AFFIDAVIT

David Manteit V Brisbane City Council & Orrs 2916/24

128 Ashridge Rd Darra questions arising from the approval including request for release of Council engineering calculations prior to S75 notice or S230 application. A006565555.

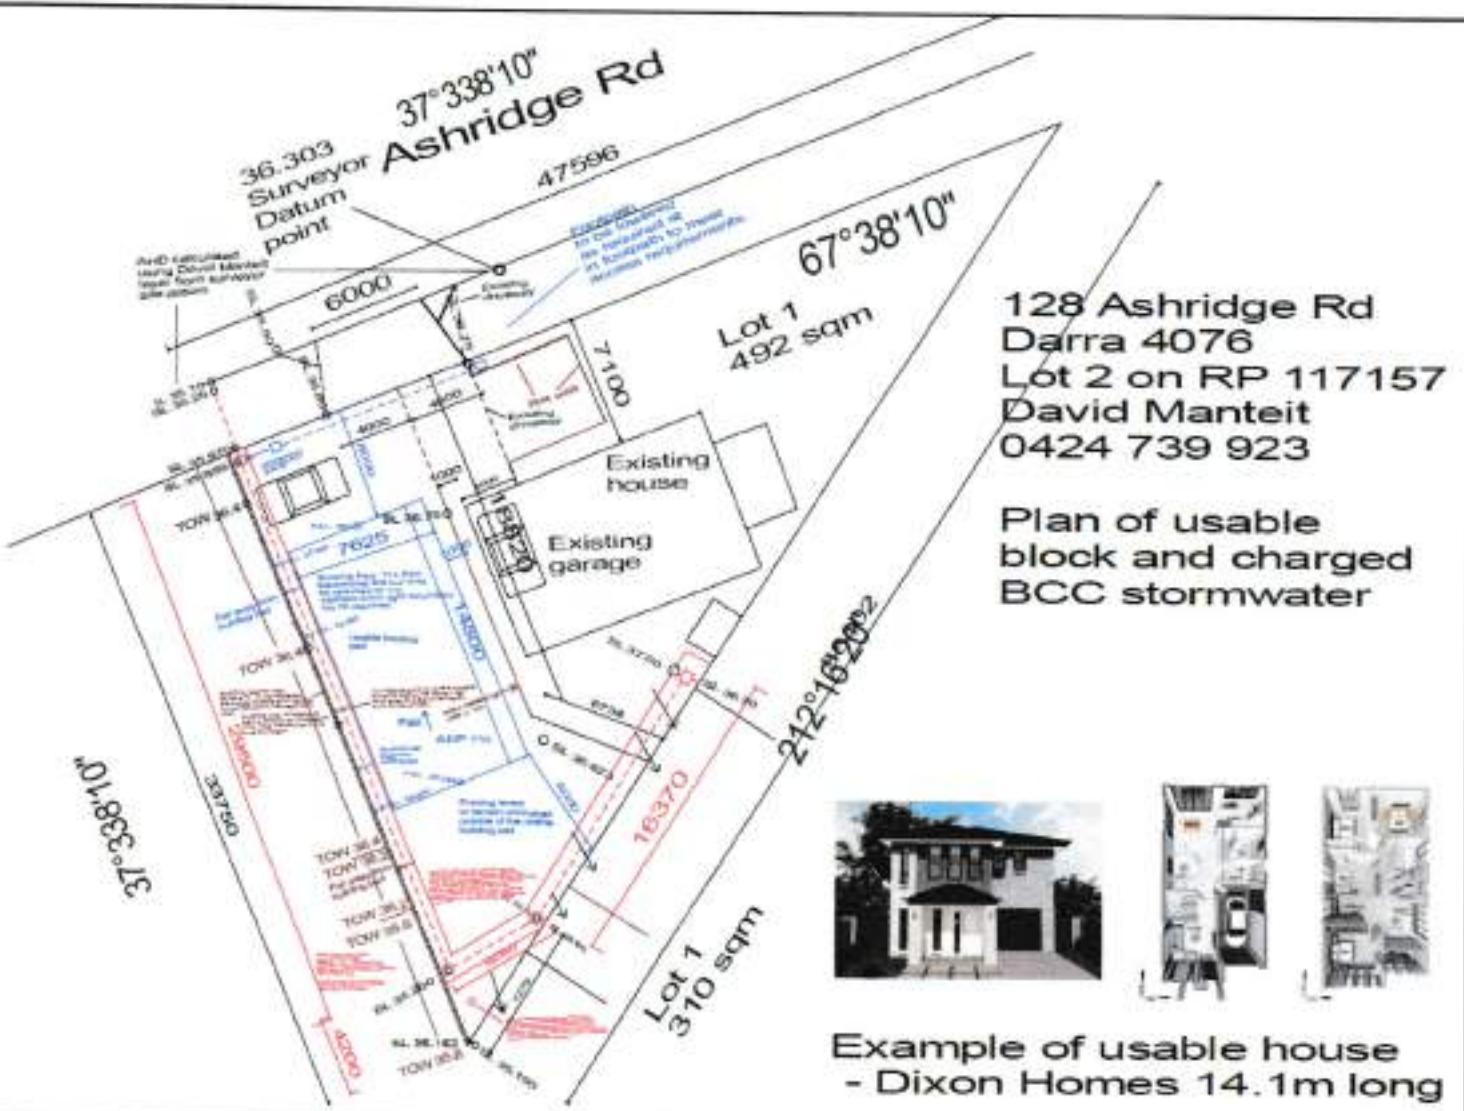
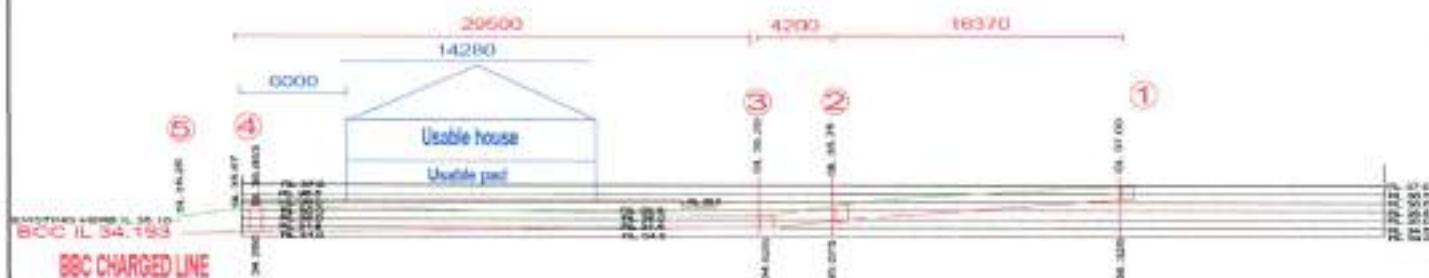
Calculations of falls of Council sham stormwater proposal red line.

Scenario 1 – minimums as per BSD 8111. 225 pipe, 450 cover, .5 degree fall.

Includes BCC sham triangle not compliant with BSD 8111 required setback of 600mm.

Scenario 2 - minimums as pre BSD 8111. 225 pipe, 450 cover, .5 degree fall.

Includes compliance with BSD 8111.

Scenario 3 – conservative 225 pipe, 600 cover, 1 degree fall

128 Ashridge Rd Darra
Stormwater side elevations

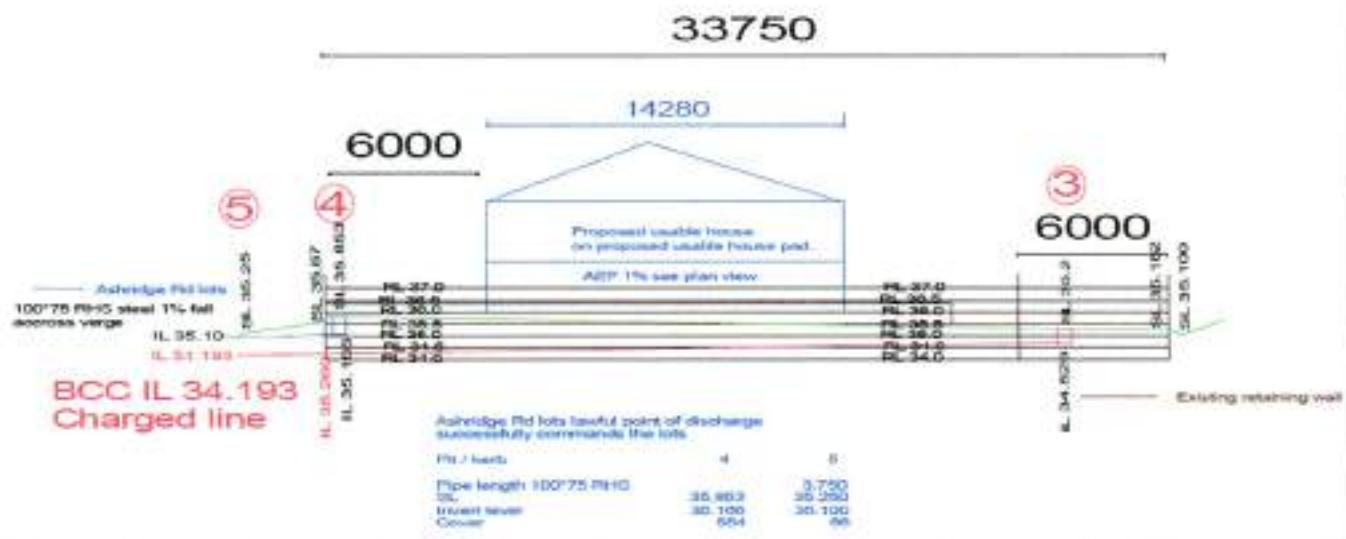
BCC CHARGED LINE for "alleged upslope" properties

Side elevations of block BCC charged stormwater line including Ashridge Rd lots lawful point of discharge.

Stormwater side elevations

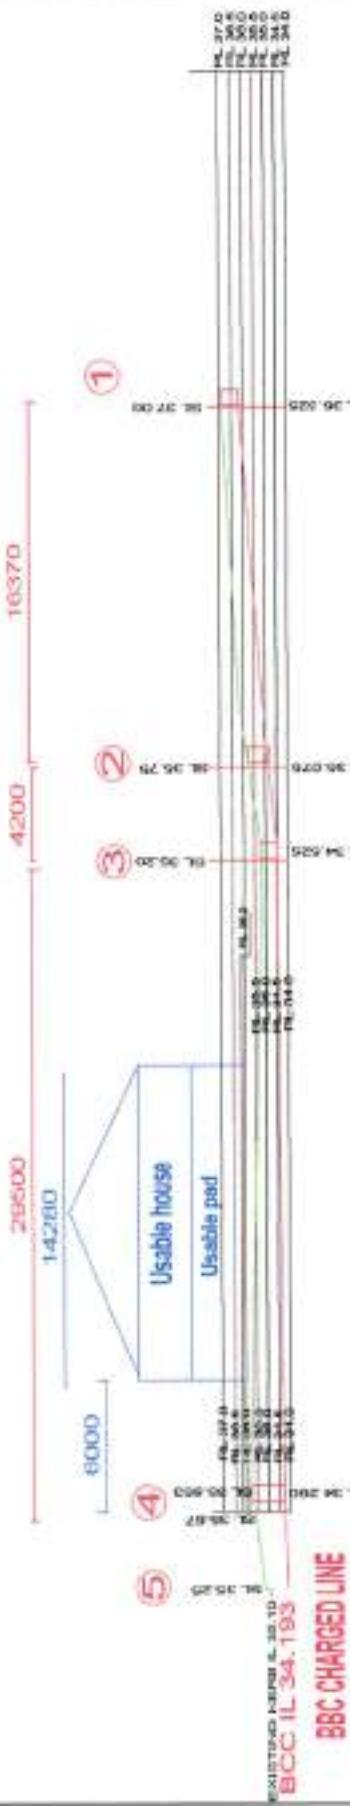
BCC CHARGED LINE for "alleged upslope" properties

BBC CHARGED LINE

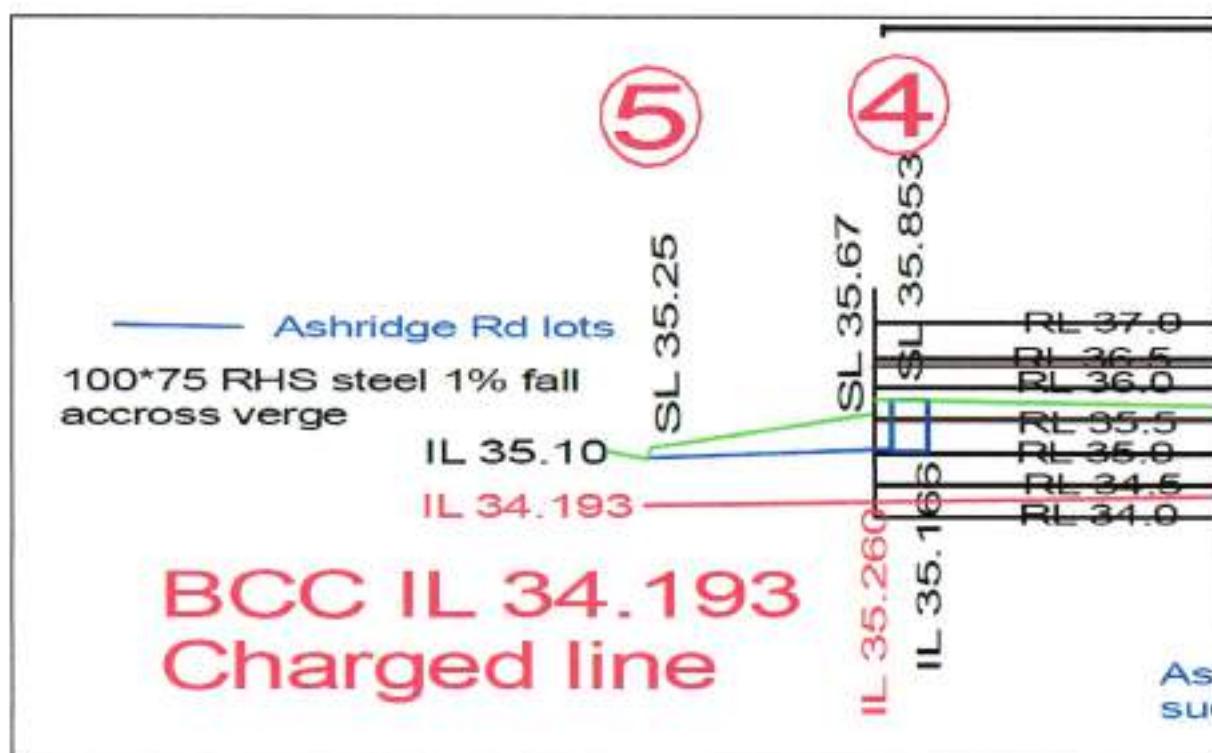
Given required one degree fall, a minimum of AHD 35.166 invert level is required at the boundary. The invert level at the boundary is proposed AHD 35.166. This level will command the the existing site levels for both Lot 1 and Lot 2 without the placement of any fill. There is no point on the block that is lower than AHD 35.166, except he right back corner of 35.162 (which is not part of the usable building pad).

5. Is Council prepared to defend their sham stormwater design using lazy markups and no detailed design against the applicant in a S75 notice or Planning Court appeal? Please advise.

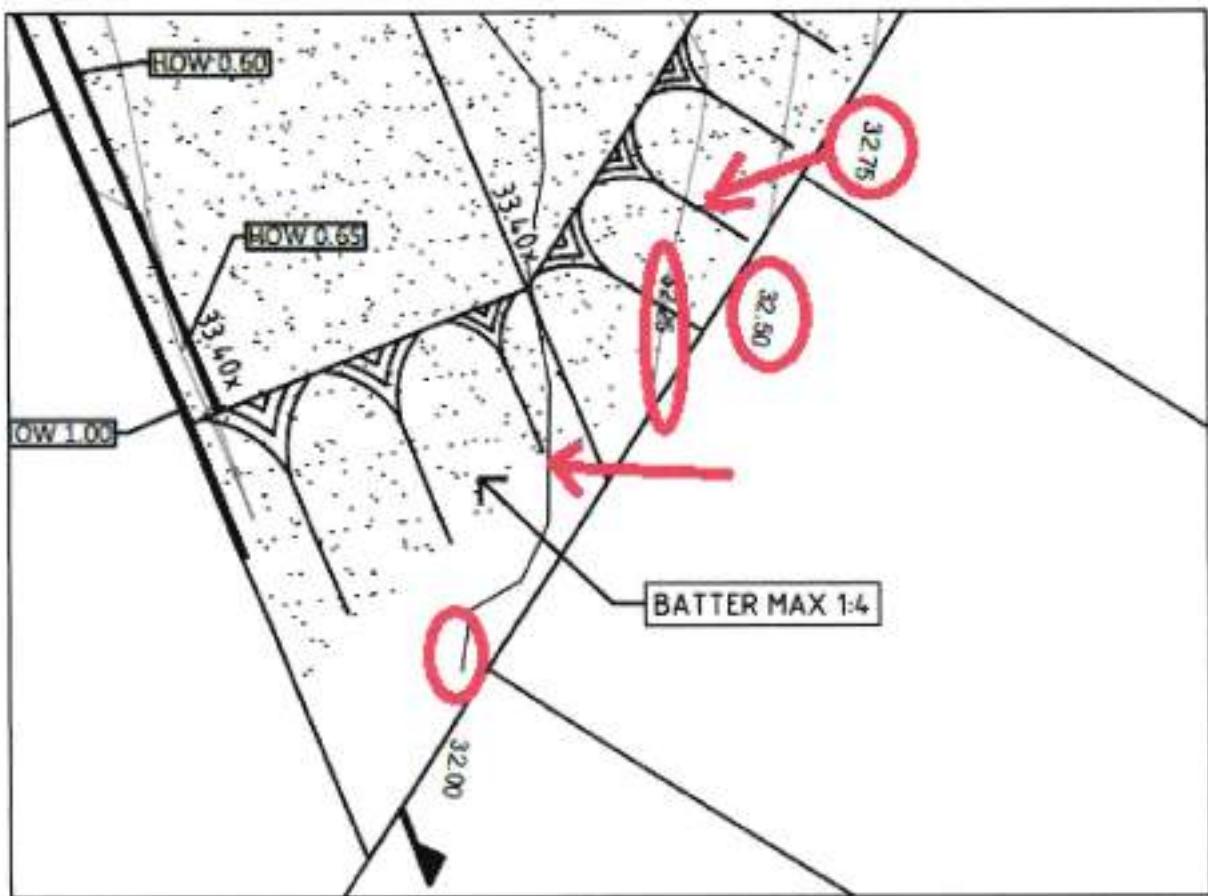
13. Please advise why 134 Ashridge Rd (17 metres away from the subject development) approval did not require a 225mm pipe to rear properties if the fall at rear boundary is to the 134 Ashridge Rd property whereas the slope at the rear for the subject property 128 Ashridge Rd, is to the rear properties.

Approved BCC plan showing fall at the rear boundary is to the subject property.

Overall slope test

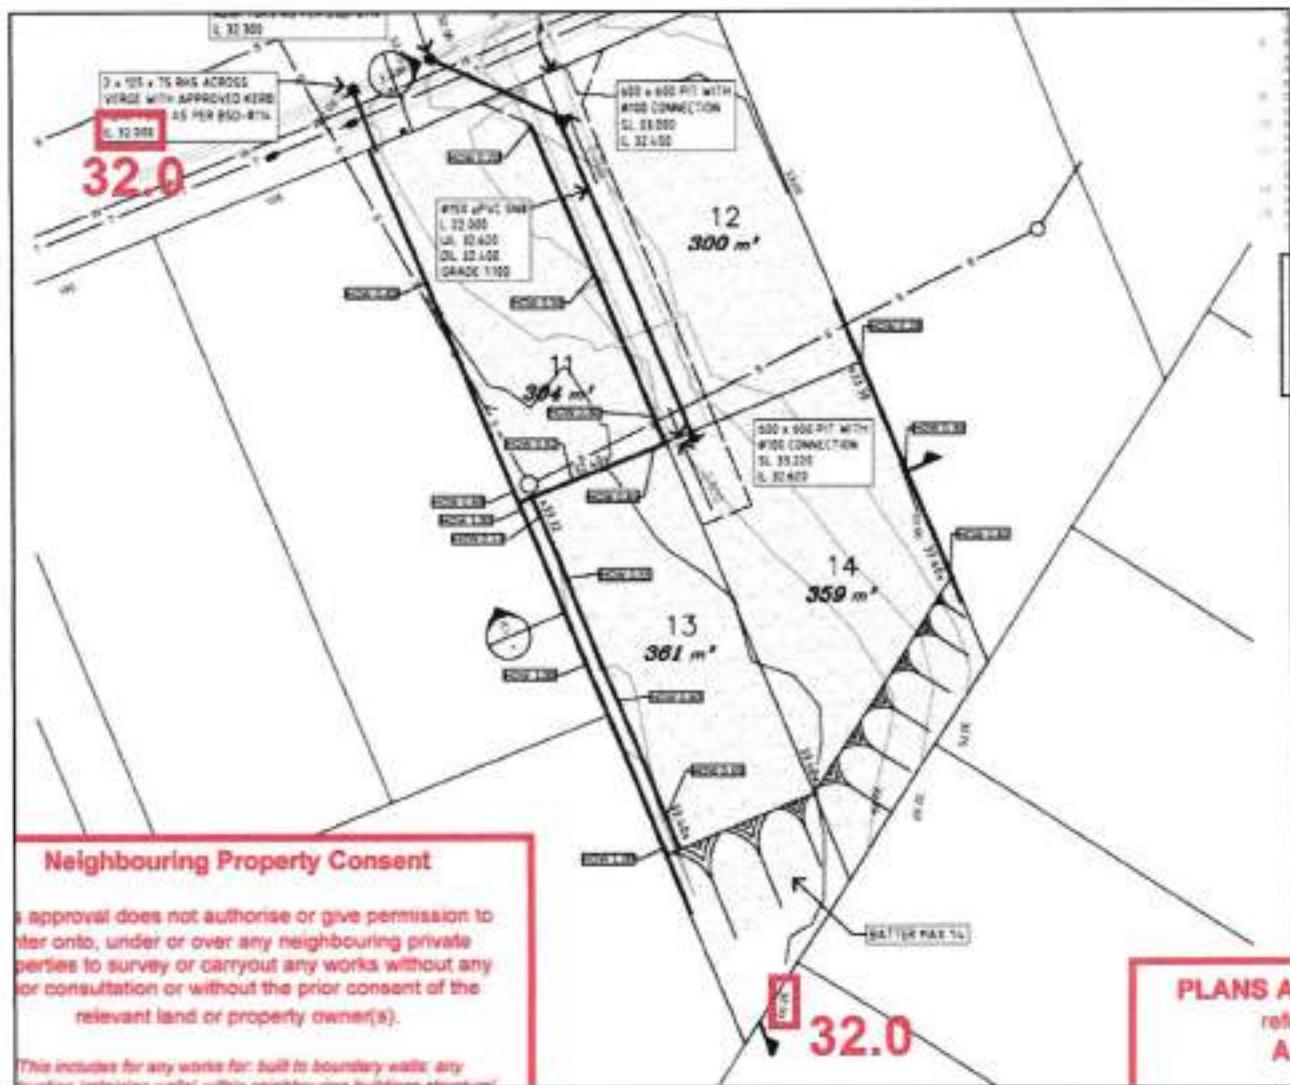
Therefore, this is not one of the tests that BCC use to determine if a property is "Upslope"

The above plan of approval for 134 Ashridge Rd Darra shows zero **Overall fall from rear to front of 32.0 to 32.0.**

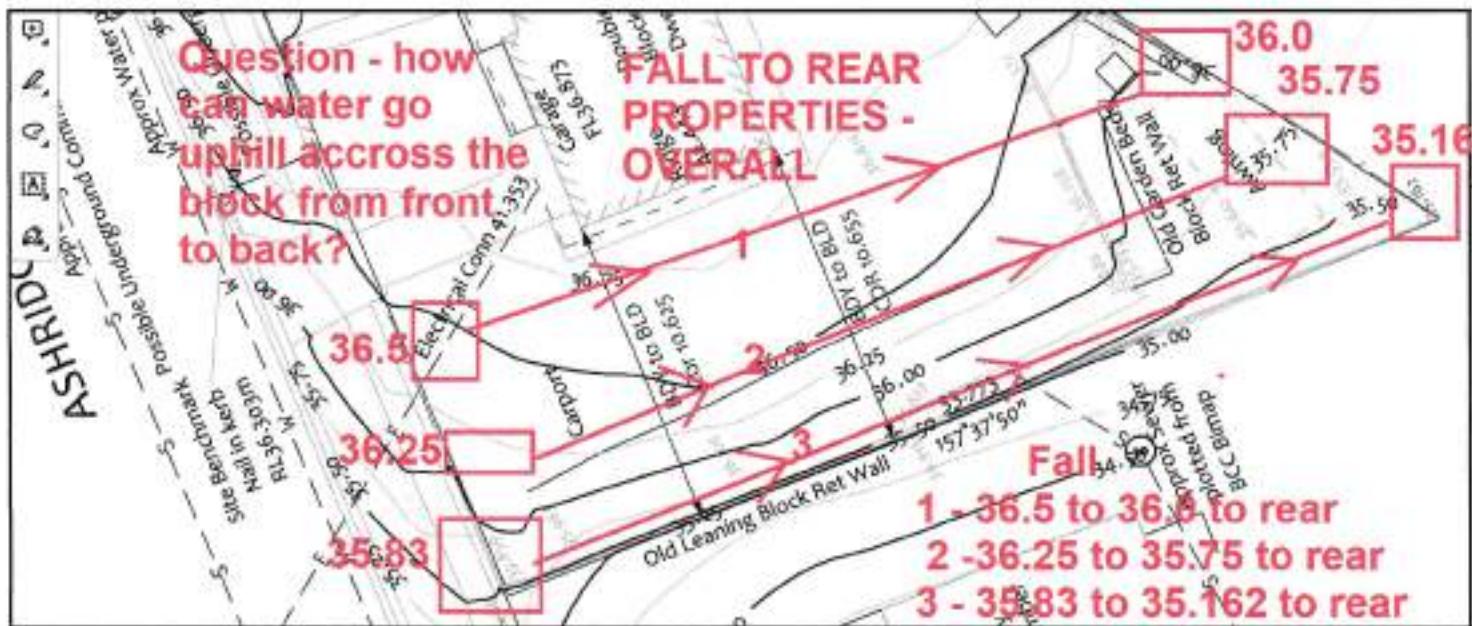
16. Will BCMT be able to inspect a stormwater end of line at the kerb that is .907mm, .984 mm, 1.269 mm below the kerb?

17. Will BCMT sign off on the inspection of the kerb at the construction phase that is a sham design?

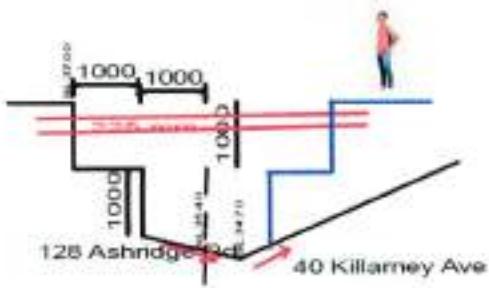
Possible crosssection of council
225 mm pipe mid air Roman aquaduct
stage one. To be confirmed by BCC.

Possible crosssection of council
225 mm pipe mid air Roman aquaduct
complete. To be confirmed by BCC.

28. Can BCC RPEQ please provide their crosssections and mathematical calculations used to determine legal point of discharge ? This includes crosssection at the stub location of Lots 98 and 99 to demonstrate they are/are not proposing a Roman Aquaduct system as above.

Figure 7.4.7a—Building near and over stormwater and subsoil drains

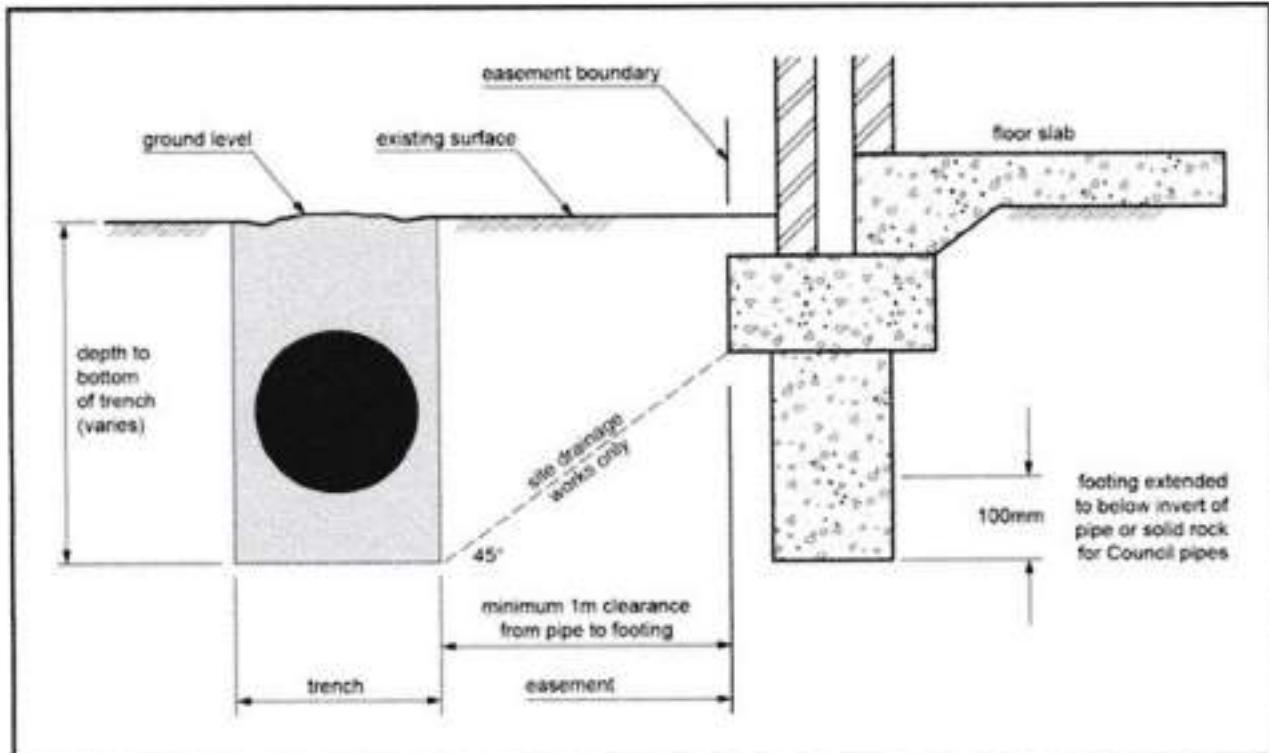
I require the Council to provide explanation of how the requirements of S 7.4.7 Building near or over underground stormwater infrastructure below can be satisfied in the Council drawn and designed red line of approval of 128 Ashridge Rd Darra by Wednesday 5pm 13-11-24.
